Model	Model Code	Year Model
ACCORD 4D	CU3	09, 10, 11
ACCORD TOURER	CW3	09, 10, 11

Issue Date
09-10-13

DPF Warning Light Comes On

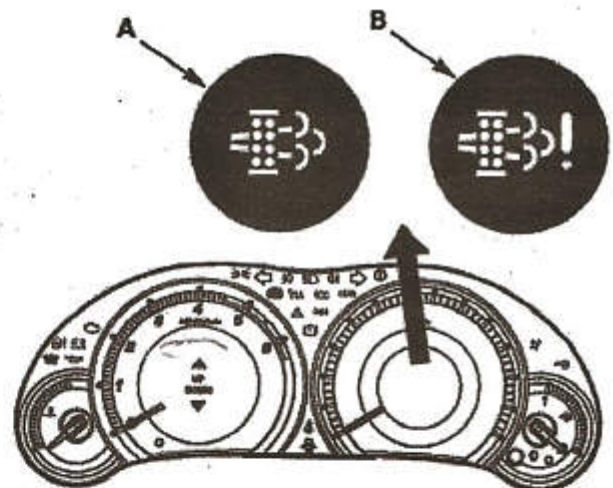
- When the CHECK SYSTEM (DPF OVER ACCUMULATION)MIL light (B) is on.
- Note: A Service Regeneration is not required for light (A): "DPF Regeneration Required". In this case, inform the customer to drive their vehicle to conditions stated in the owners manual to regenerate the DPF system.

1. Update the ECM Software using HDS version 3.008.027 or later.
2. Carry out a Service Regeneration following the latest method as described in this Service bulletin.

*: This illustration shows Left Hand Drive model. Right Hand Drive is similar.

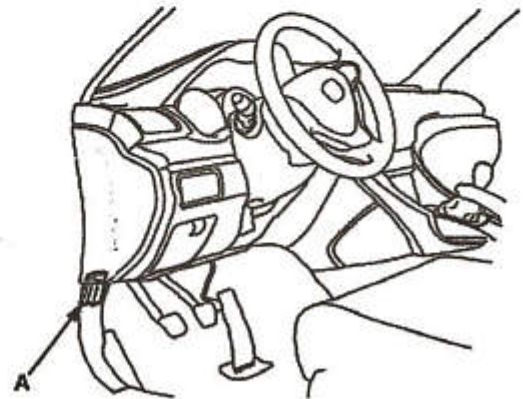
1. Check the engine oil level. If the level is +20 mm (0.79 in.) above the upper level mark, replace the engine oil.
2. Turn the ignition switch to ON (II).
3. Connect the HDS to the data link connector (DLC) (A) located under the driver's side of dashboard.
